#### **Addendum 116 – Regulation No. 117**

#### **Revision 3 - Amendment 2**

Supplement 6 to the 02 series of amendments – Date of entry into force: 9 October 2014

#### **Uniform provisions concerning the approval of tyres with regard to rolling sound emissions and/or to adhesion on wet surfaces and/or to rolling resistance**

Figure 1  
 Nomenclature explanation related to grip index of the tyre

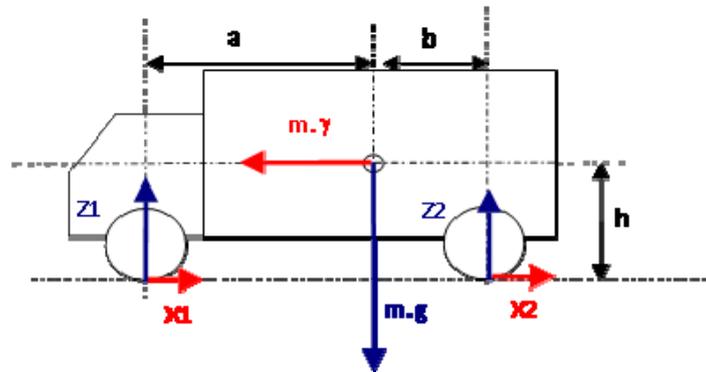
The Wet grip index represents the relative performance of the candidate tyre compared to the reference tyre. The way to obtain it depends on the test configuration as defined in paragraph 2.2.2.2. of this annex. The wet grip index of the tyre is calculated as reported into Table 3:

Configuration C1: candidate tyres on both axles	$\text{Wet Grip Index} = \frac{BFC(T)}{BFC(R)}$
Configuration C2: candidate tyres on front axle and reference tyres on rear axle	$\text{Wet Grip Index} = \frac{(BFC(T) \cdot [a + b + h \cdot BFC(R)] - a \cdot BFC(R))}{BFC(R) \cdot [b + h \cdot BFC(T)]}$
Configuration C3: reference tyres on front axle and candidate tyres on rear axle	$\text{Wet Grip Index} = \frac{(BFC(T) \cdot [-a - b + h \cdot BFC(R)] + b \cdot BFC(R))}{BFC(R) \cdot [-a + h \cdot BFC(T)]}$

Where:

*N.B.* When "h" is not precisely known, these worst case values shall apply: 1.2 for configuration C2, and 1.5 for configuration C3
